ACKNOWLEDGMENT OF ADDENDUM #3

We do hereby acknowledge the information and/or changes described in
Addendum #3 to Request for Proposals 2025-006 Pinebrooke 5 Renovation Phase 1

Addendum No:	#1	Issue Date:	10/6/25
Project:	HCSO Training Academy Phase 1	To Drawings + Specifications dated	8/6/2025
Prepared By:	Harvard Jolly PBK 5201 W. Kennedy Blvd. Suite 515 Tampa, FL 33609		
PBK Project No:	23106

TRAINING ACADEMY - PHASE 1

G-081

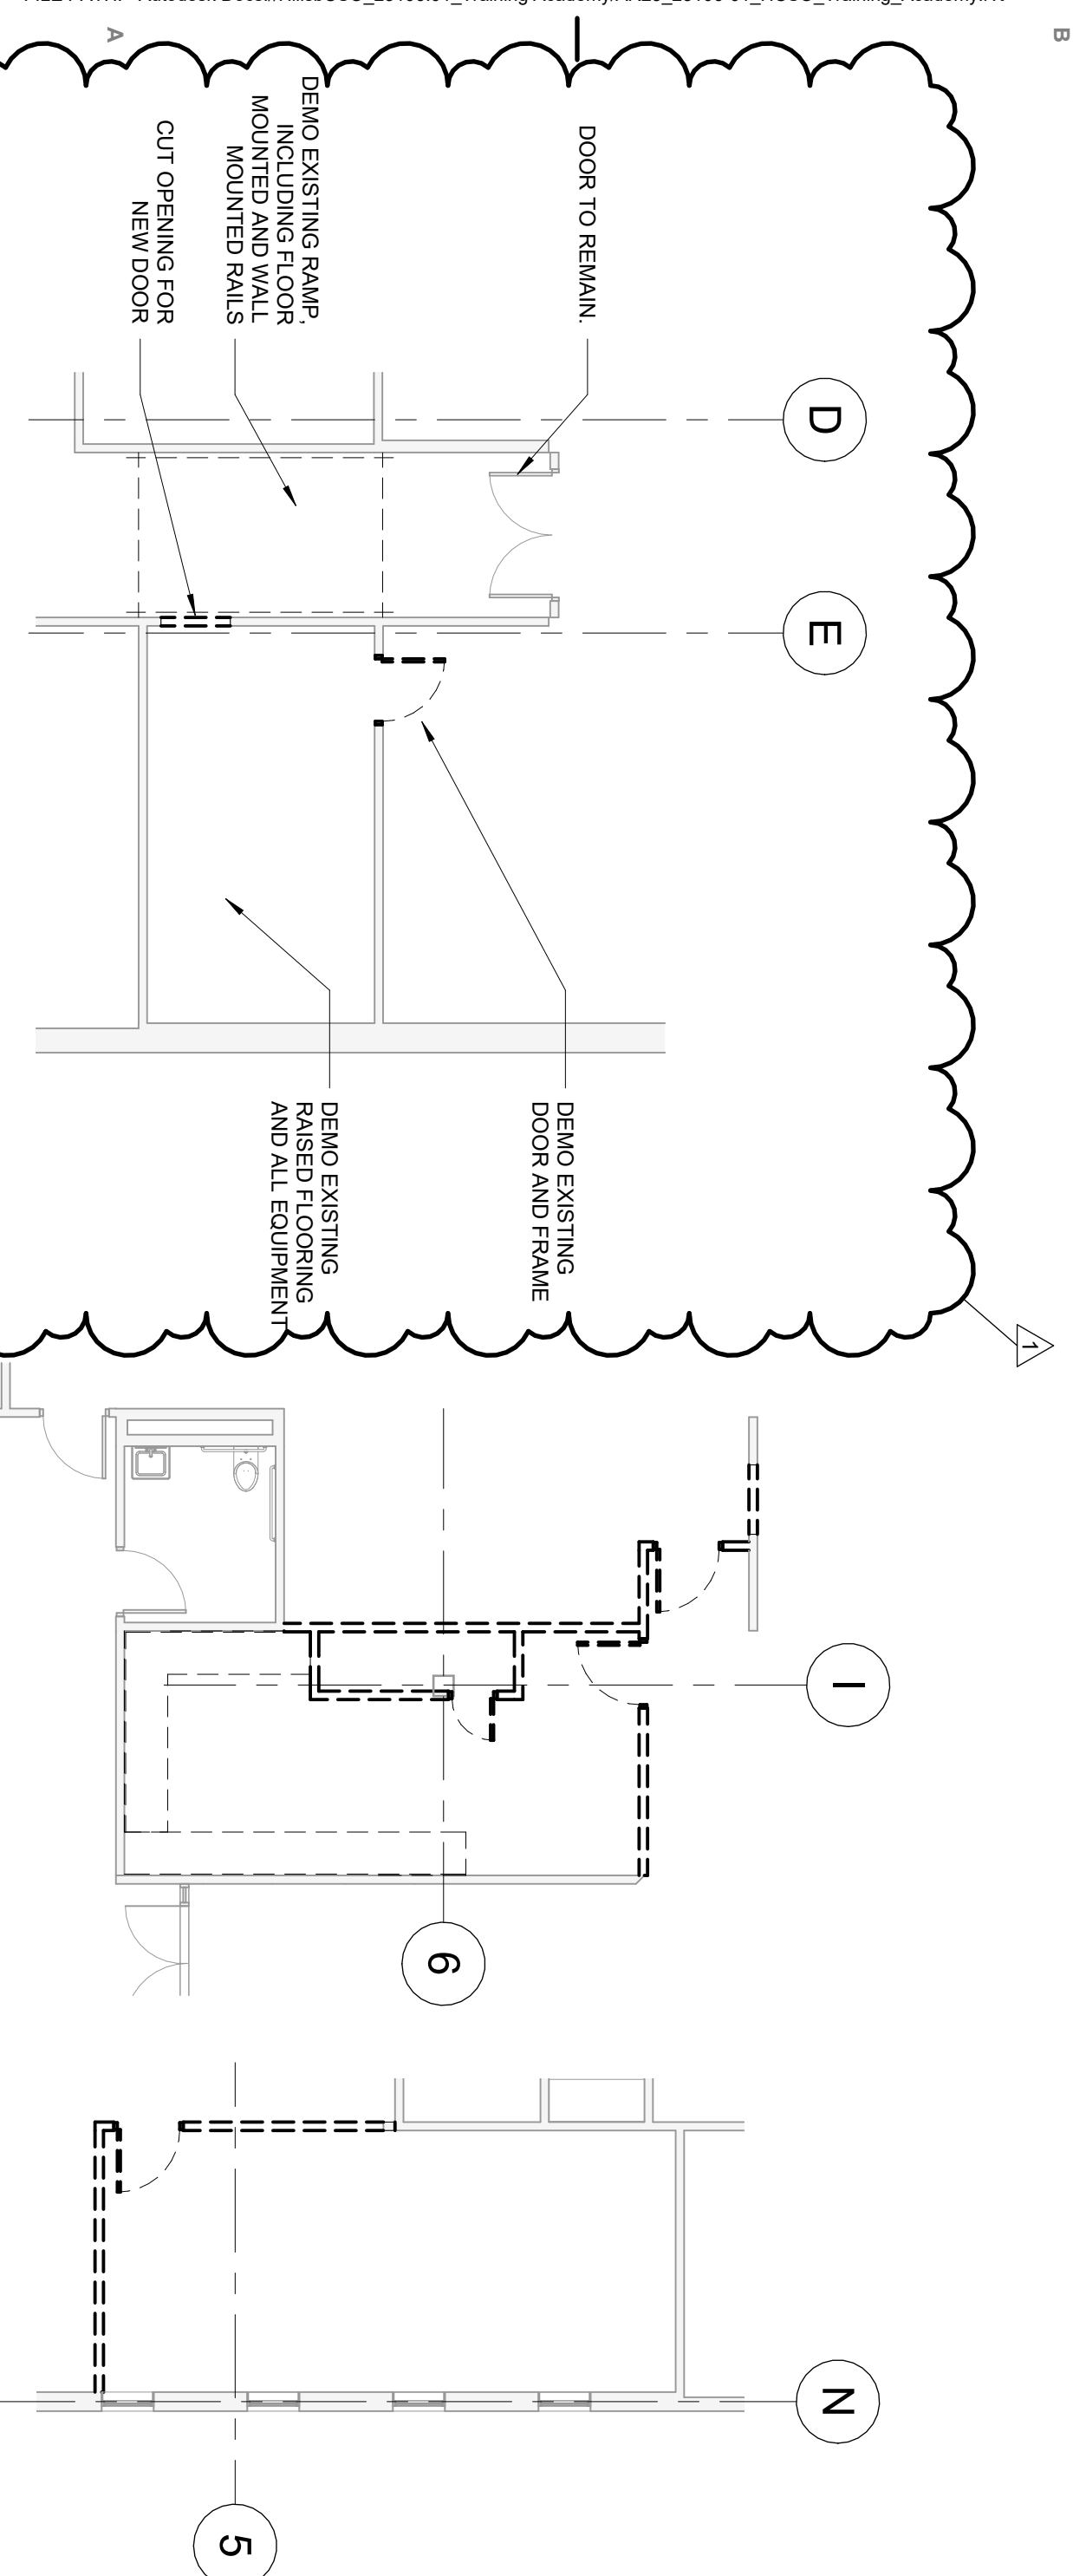
G-081: Narrative and graphic depiction of Add Alternates 2 and 3.

A-010

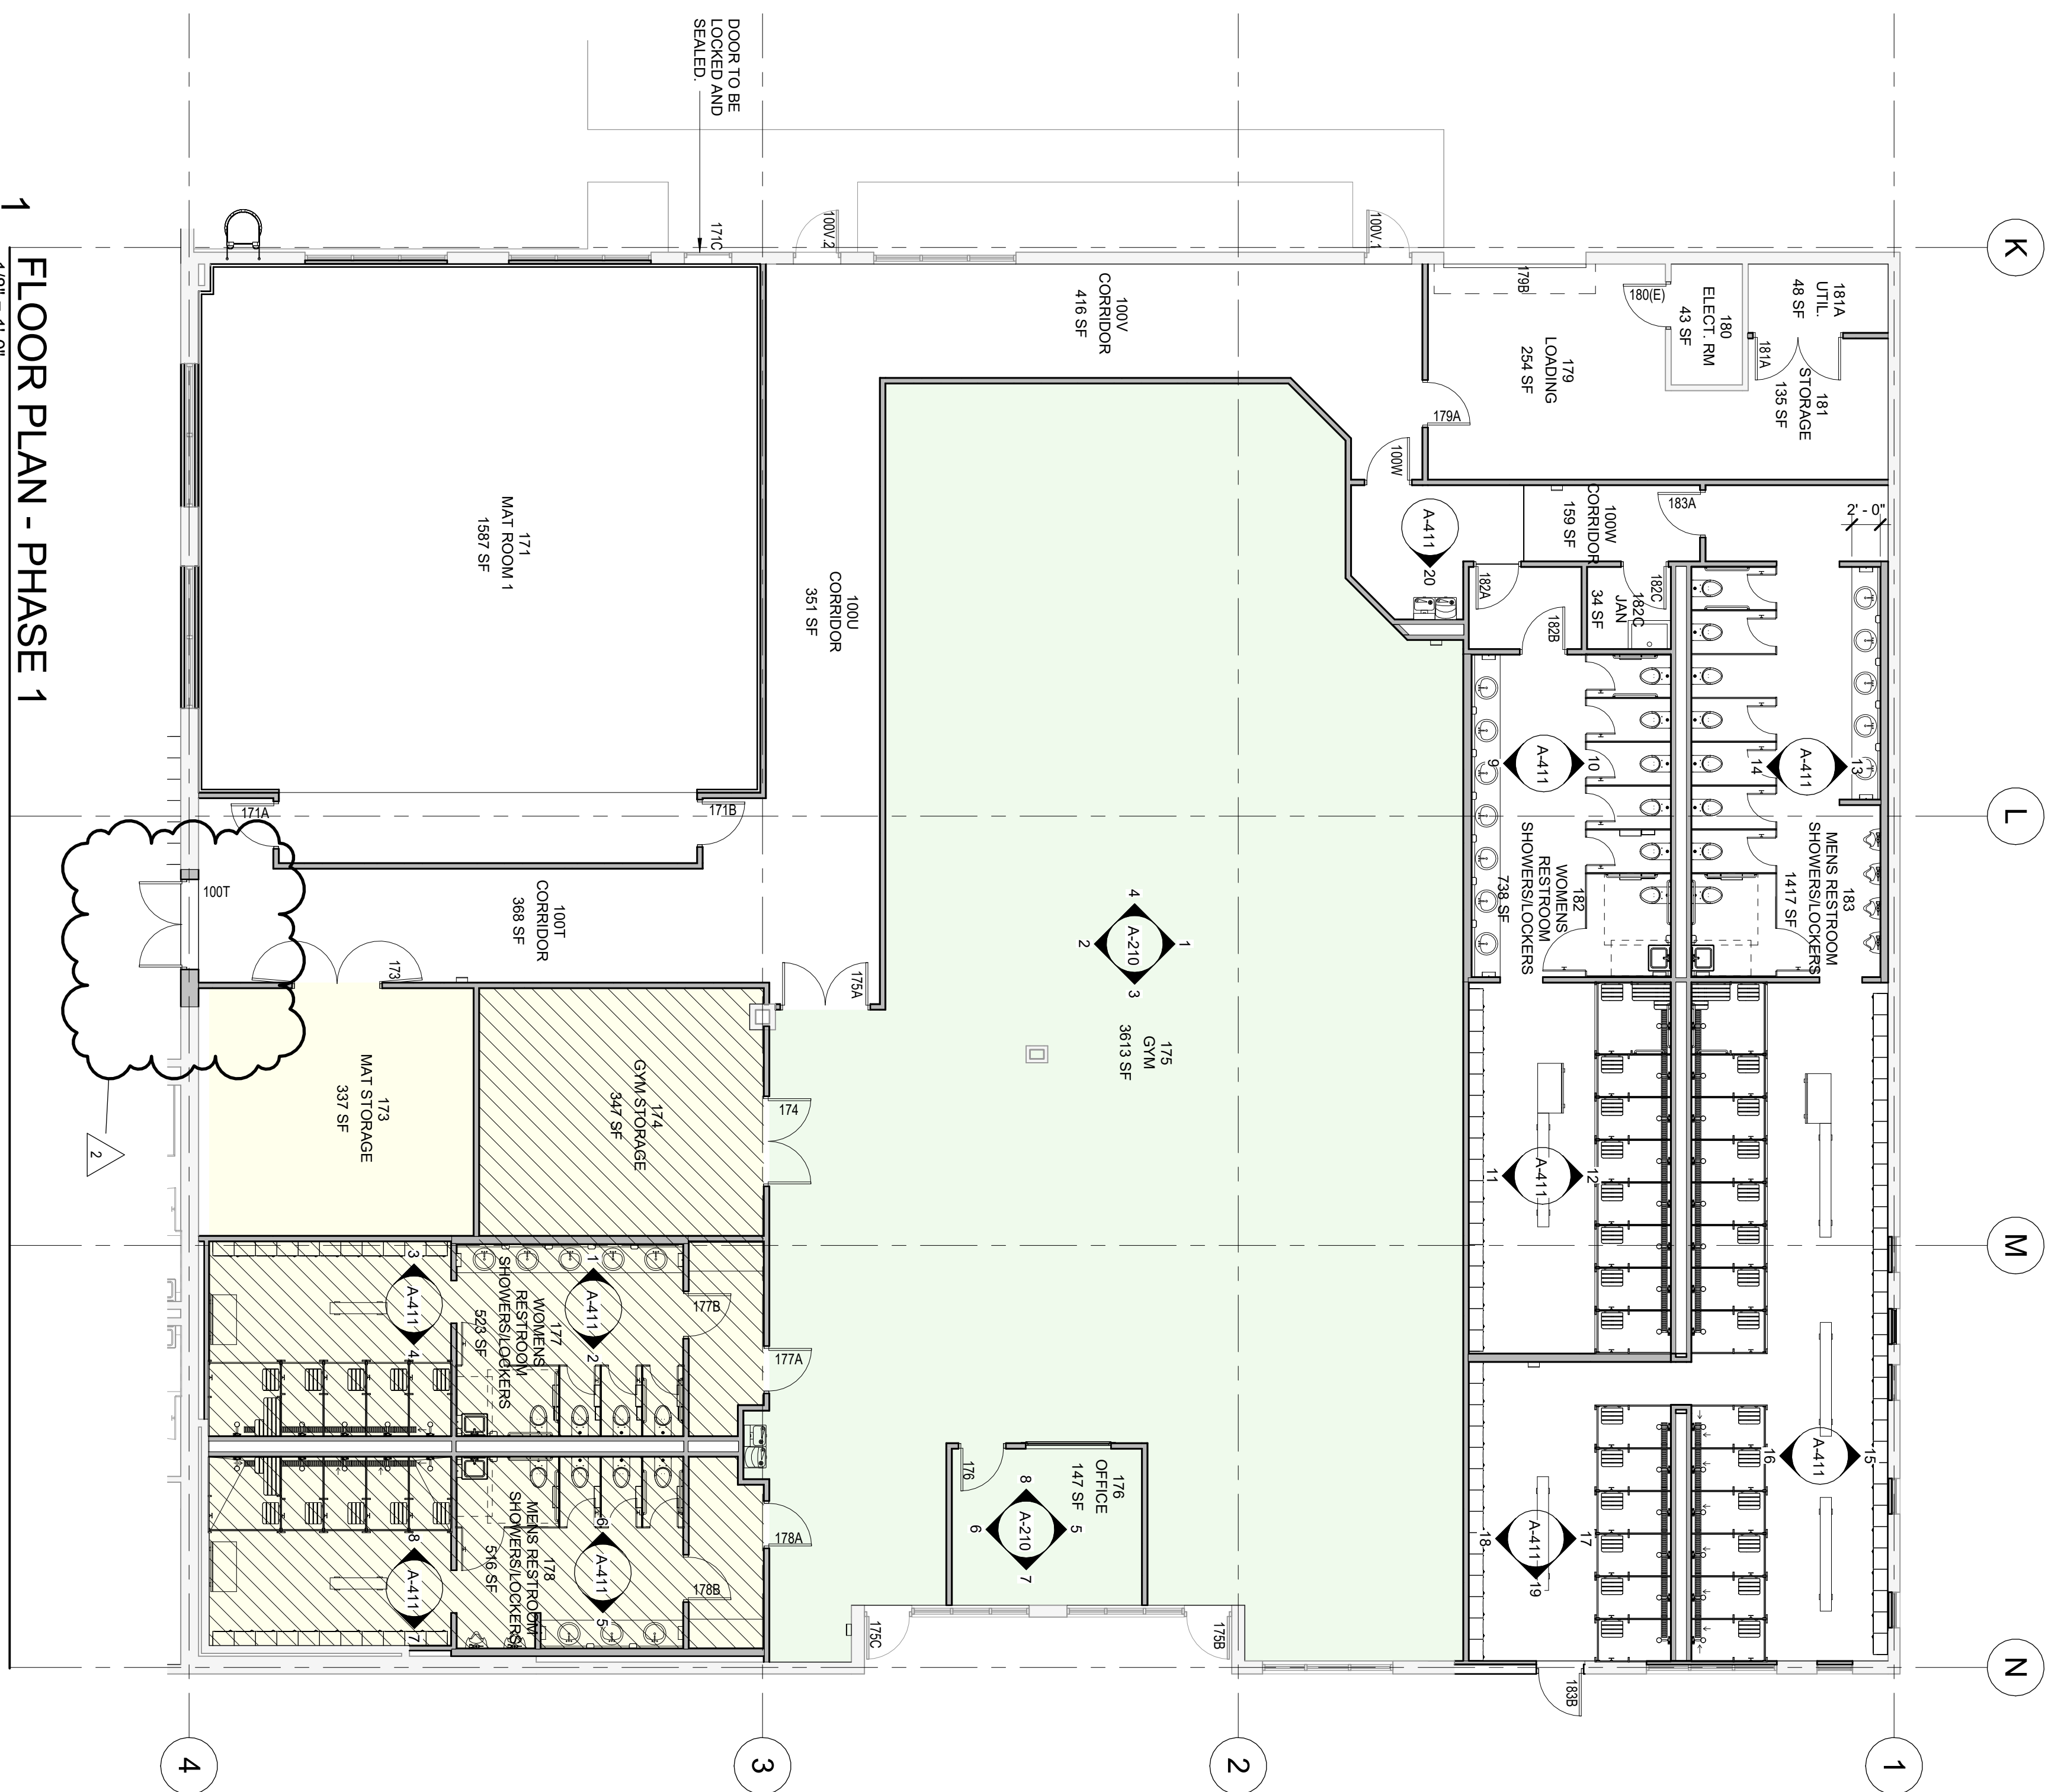
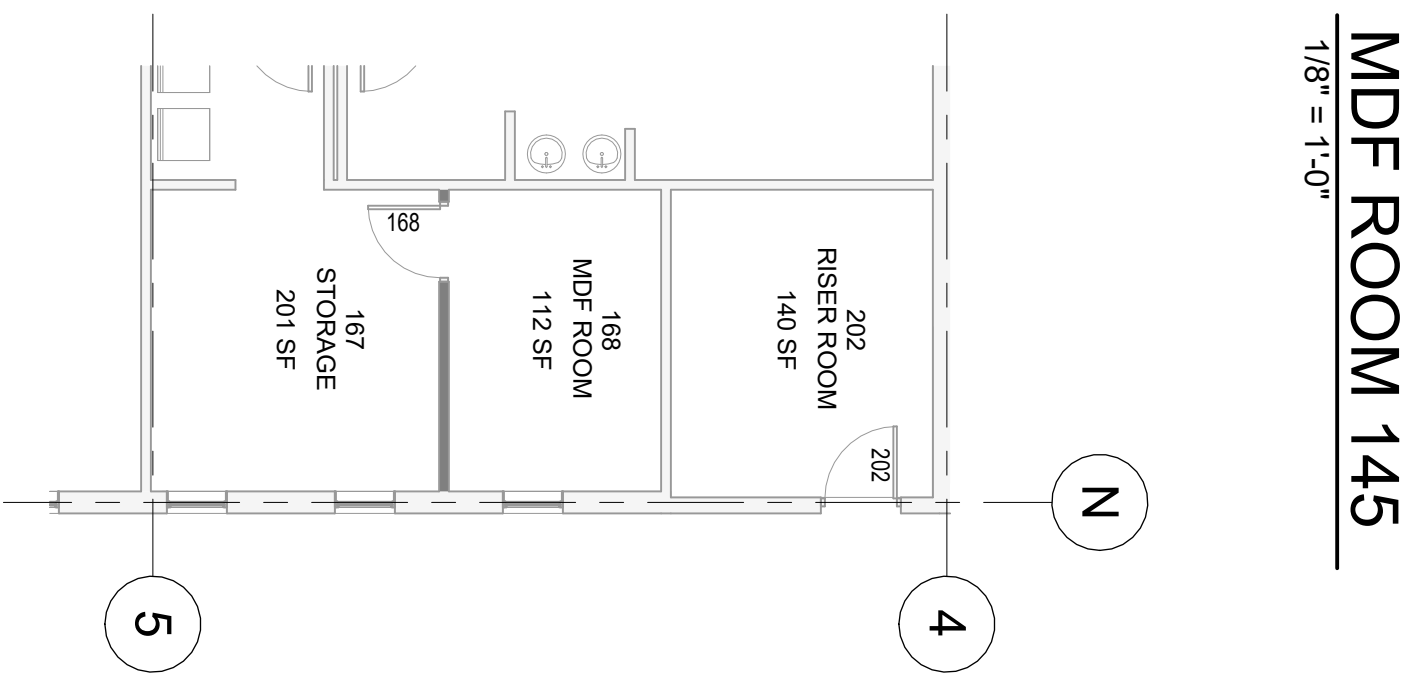
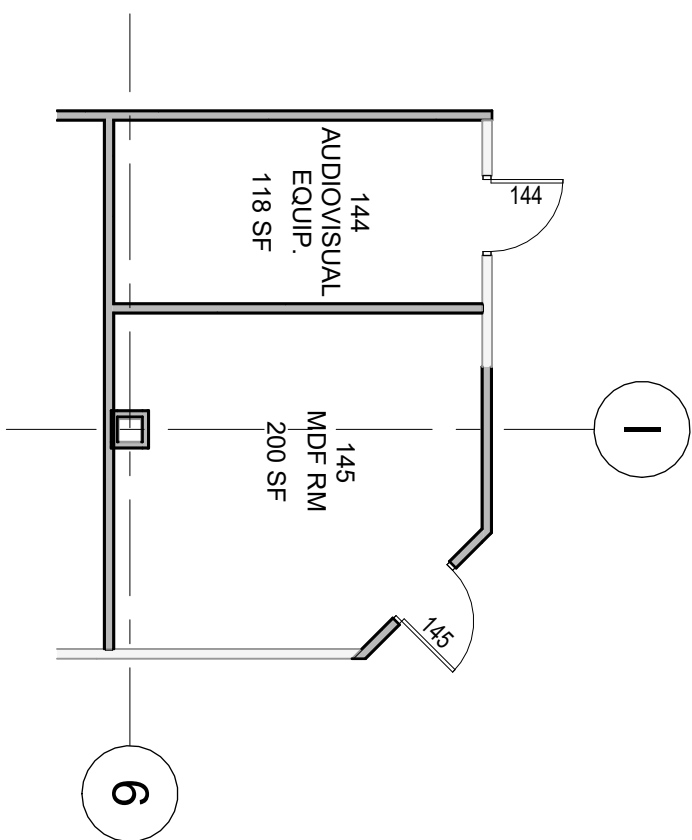
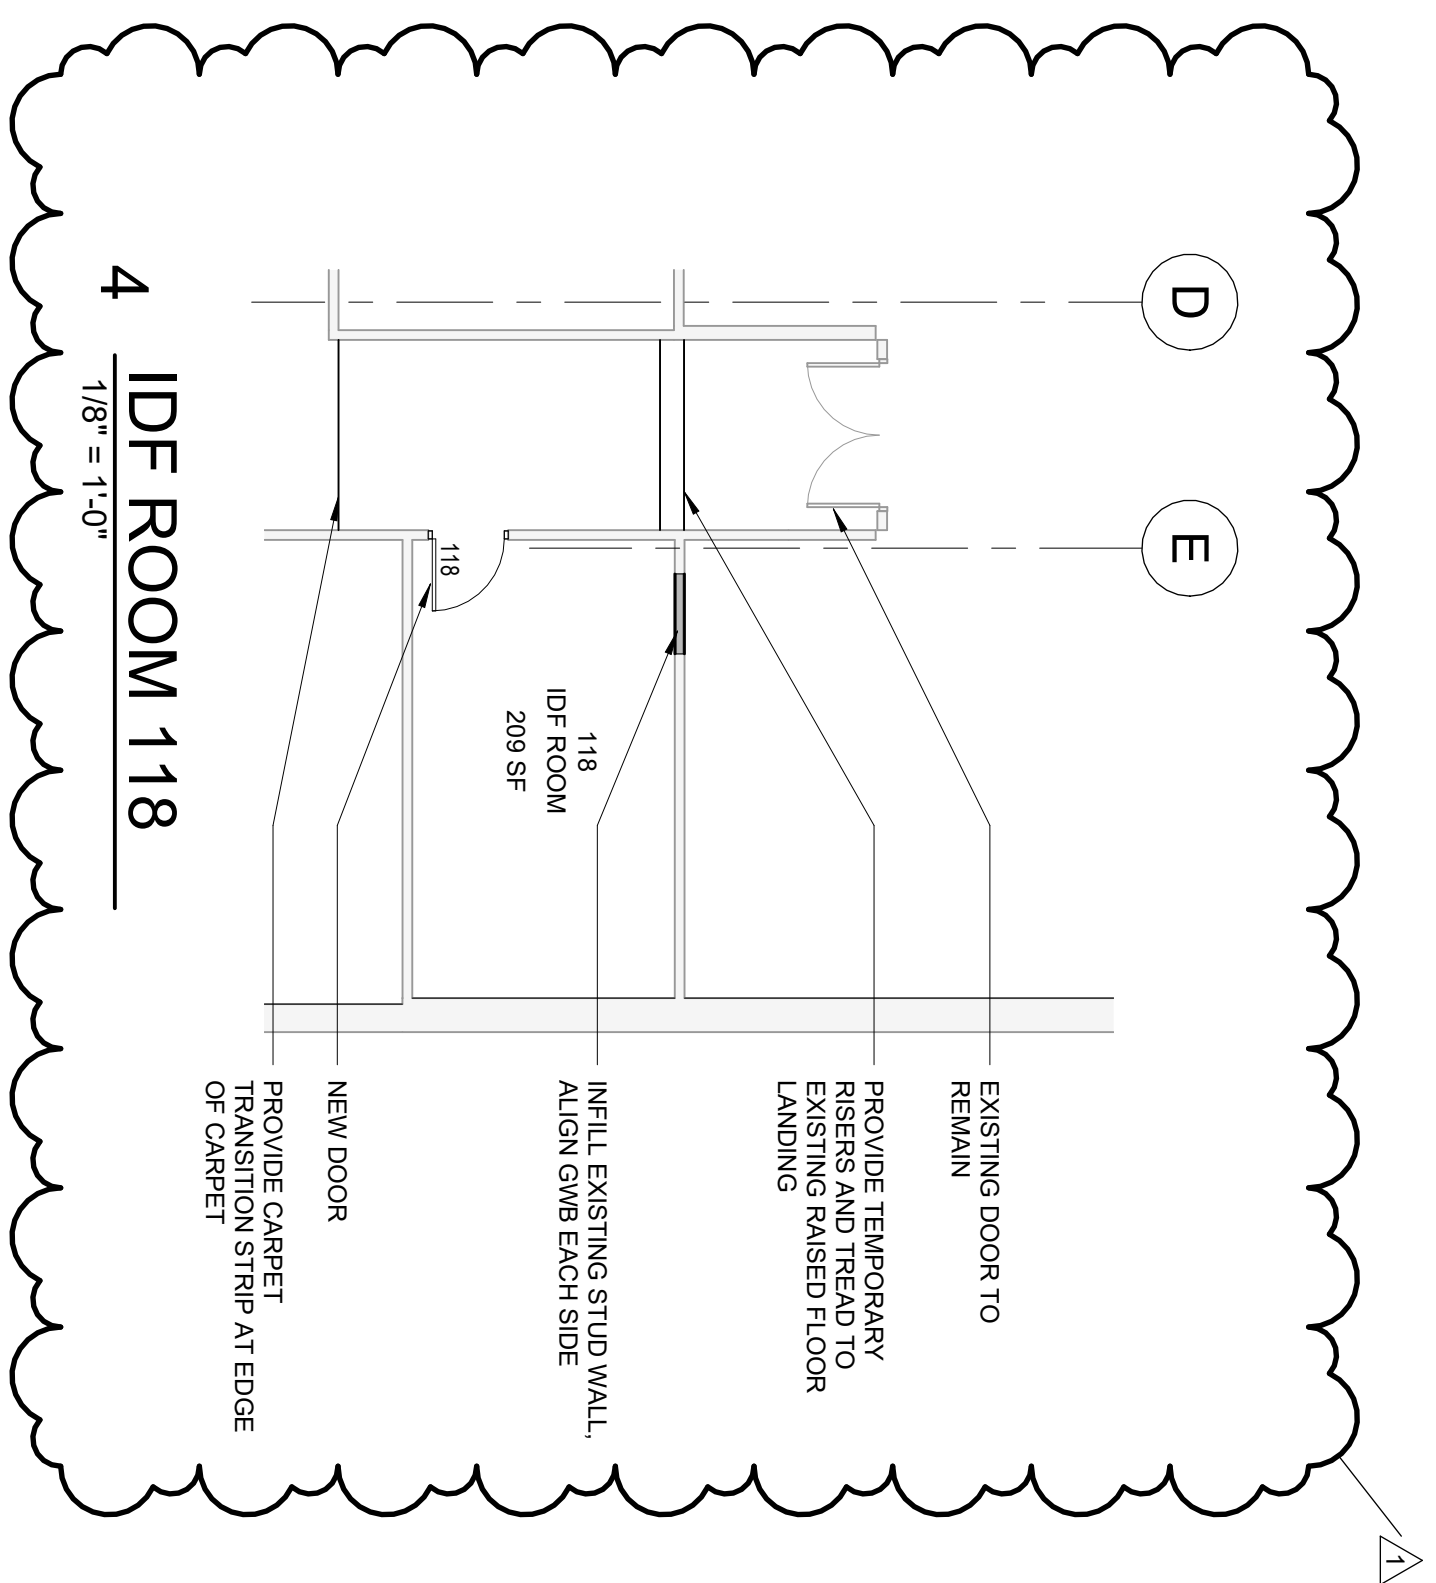
A-010: Revised Door 100T swing and added exit light at Corridor 100W.
